North Dakota Department of Transportation

ADDENDUM 4 – JOB 19

TO: All prospective bidders on project NH-RSS-1-003(034)059, Job No. 19 scheduled for the November 14, 2014 bid opening.

Revised 10/31/2014	STATE	PROJECT NO.	SECTION NO.	SHEET NO.
	ND	NH-RSS-1-003(034)059	60	6

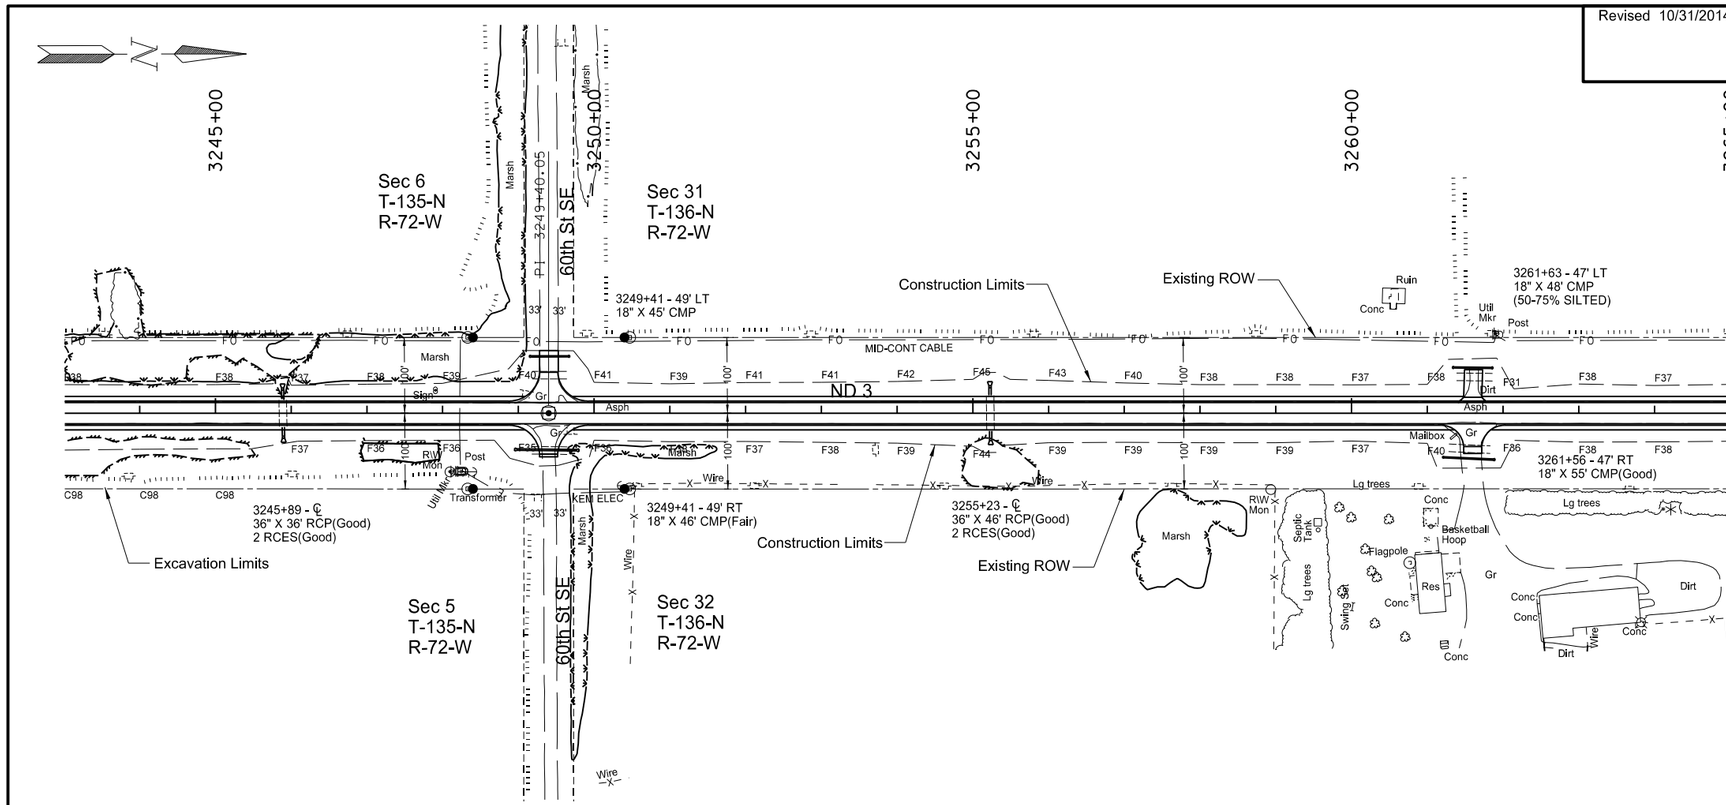
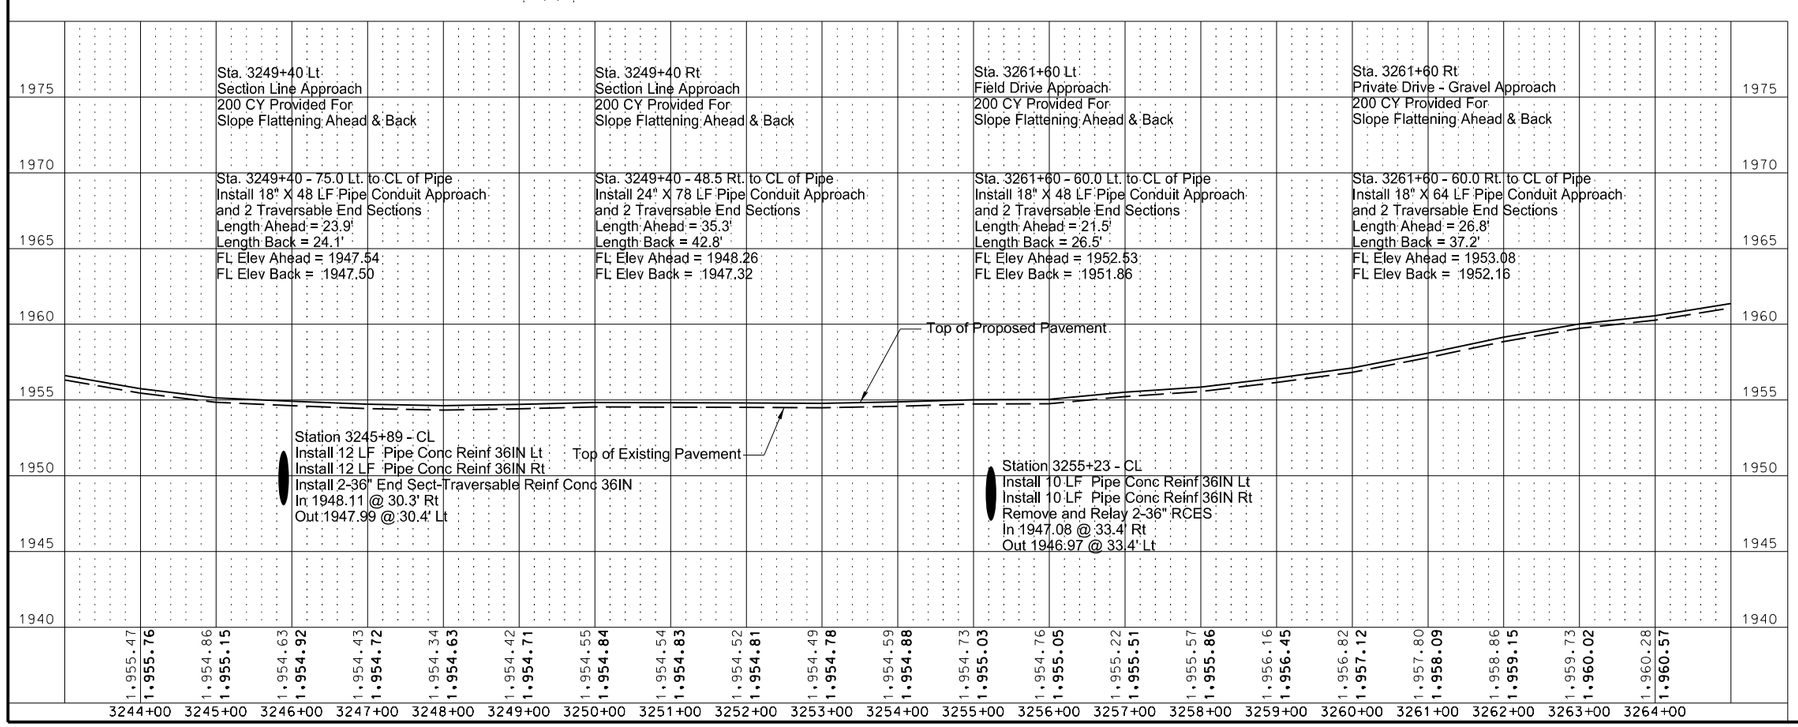
Section No. 60, Sheet No. 6:

- Added Wetland 44.
- Updated the Construction Limits.

Revised 10/31/2014	STATE	PROJECT NO.	SECTION NO.	SHEET NO.
	ND	NH-RSS-1-003(034)059	60	41

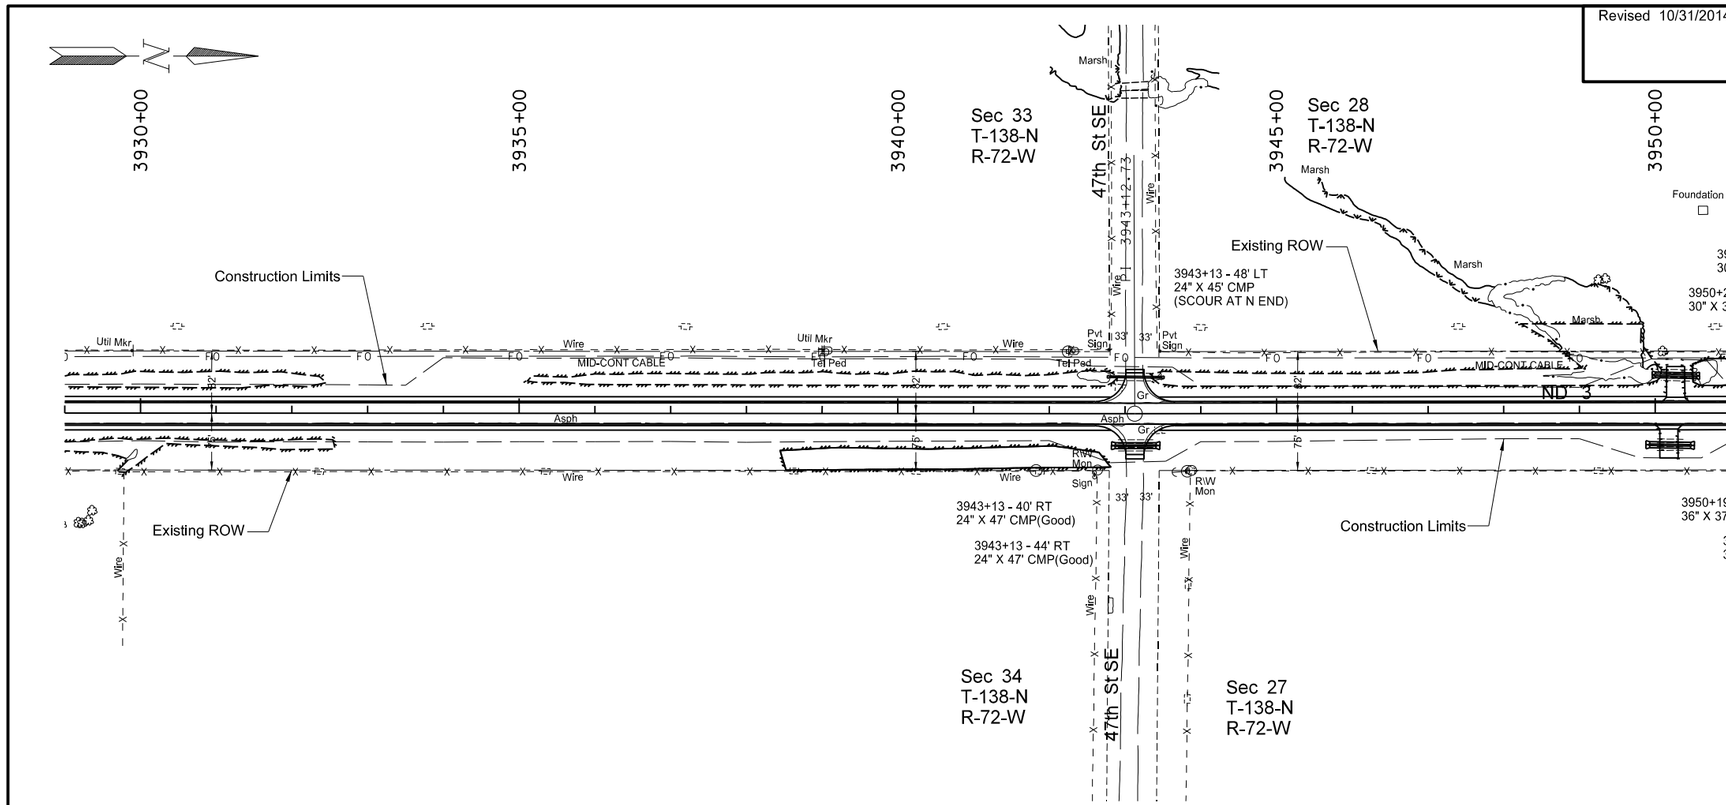
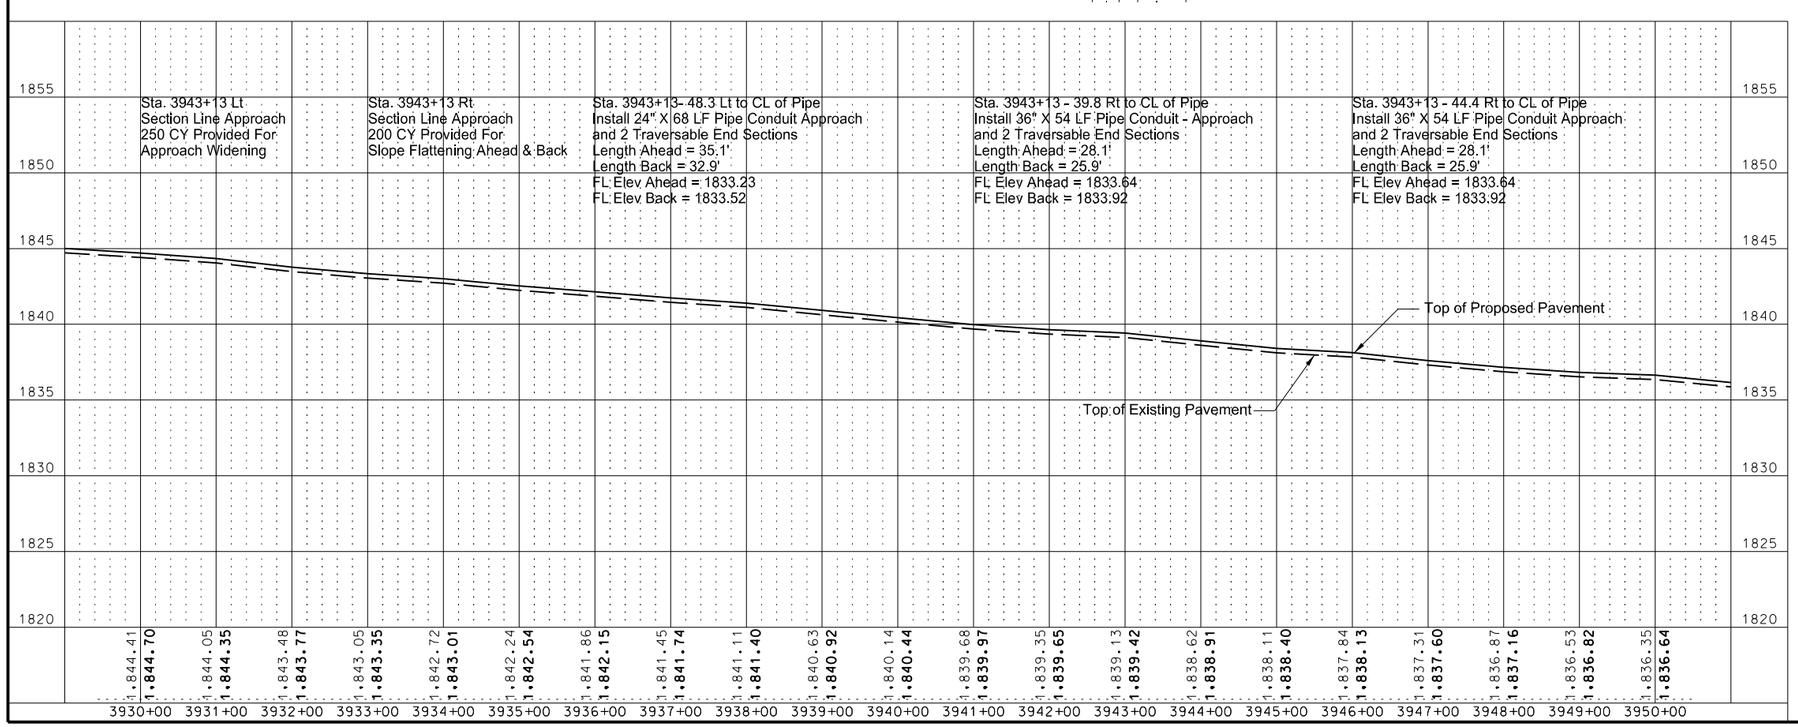
Section No. 60, Sheet No. 41:

- Added Wetland 14-E.
- Updated the Construction Limits.

Revised 10/31/2014	STATE	PROJECT NO.	SECTION NO.	SHEET NO.
	ND	NH-RSS-1-003(034)059	60	69

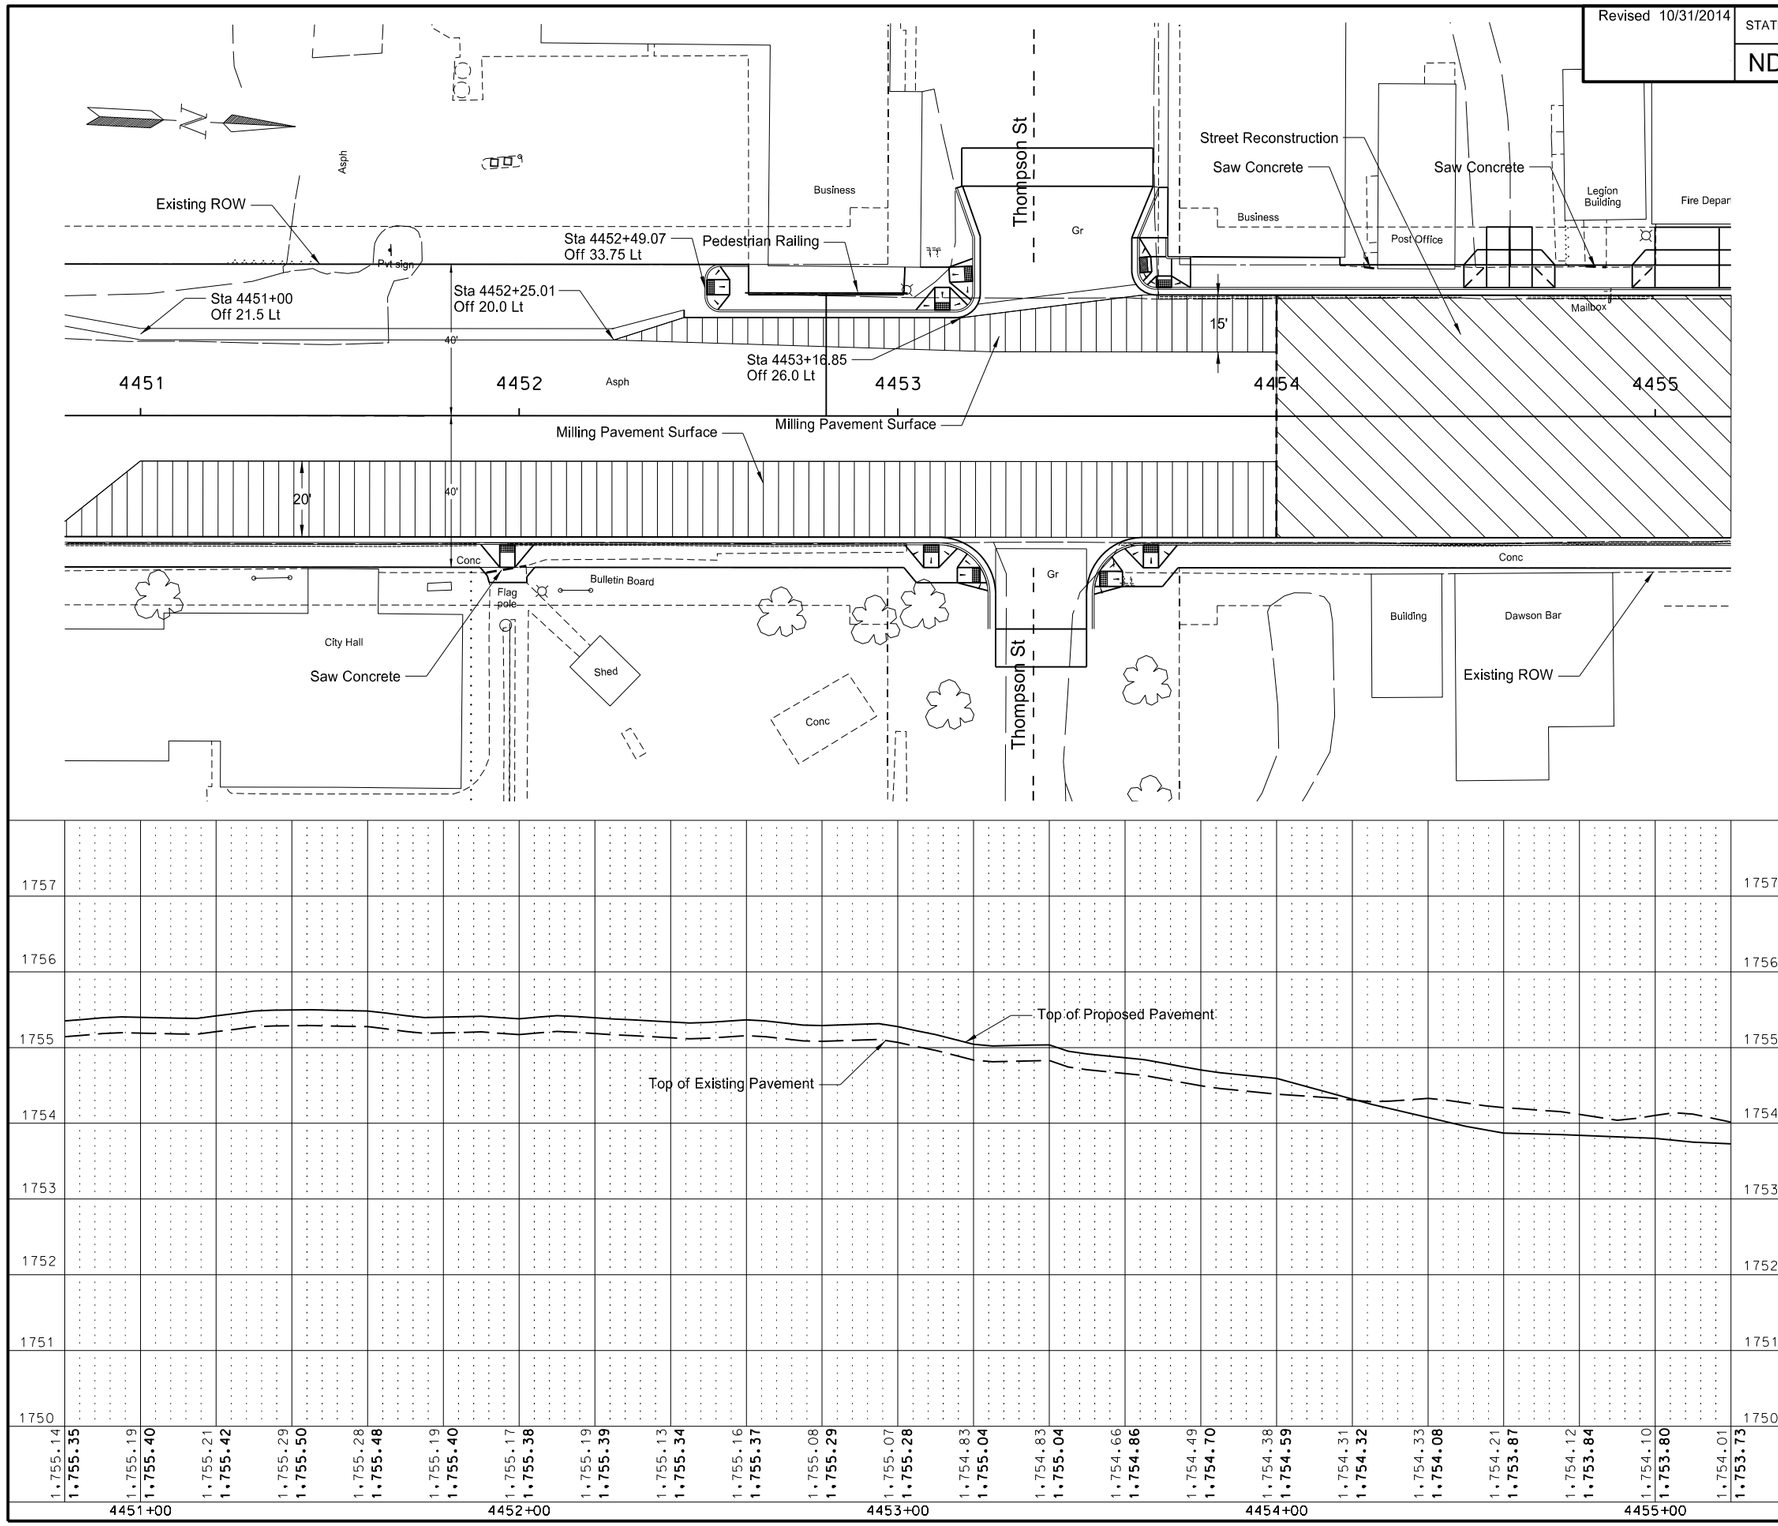
Section No. 60, Sheet No. 69:

- Updated the layout of the curb and gutter and ramps.
- Added 43 LF of Pedestrian Railing.
- Added 26 LF of Curb and Gutter Type 1.
- Removed 17 LF of Curb Type 1.
- Removed 6 SY of 36" Valley Gutter.
- Added 6 SY of Sidewalk Concrete.
- Added 38 SF of Detectable Warning Panels.

Revised 10/31/2014	STATE	PROJECT NO.	SECTION NO.	SHEET NO.
	ND	NH-RSS-1-003(034)059	75	3

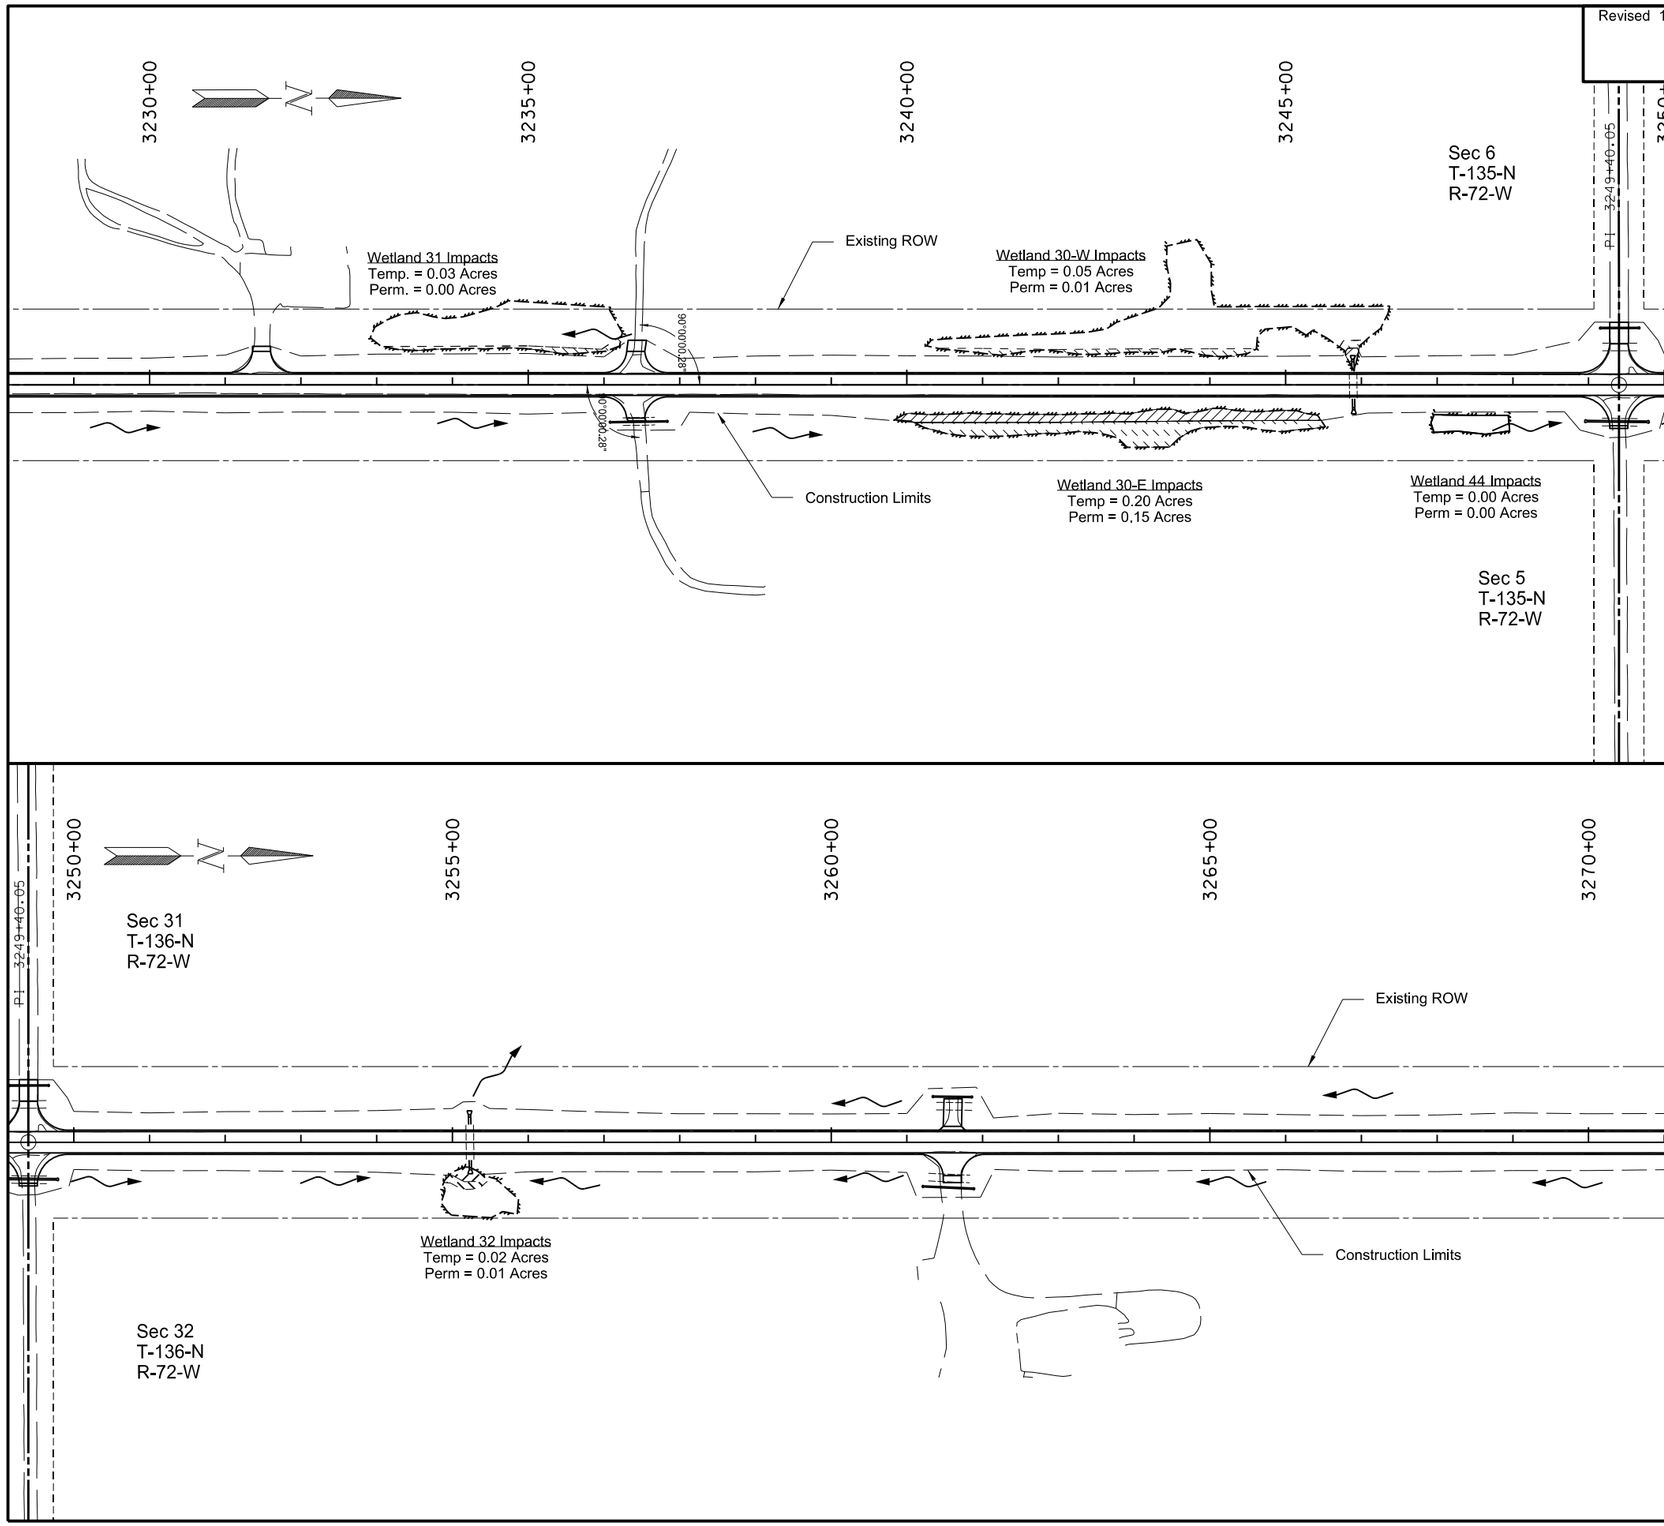
Section No. 75, Sheet No. 3:

- Wetland 44 was added to sheet.
- Updated Construction Limits.
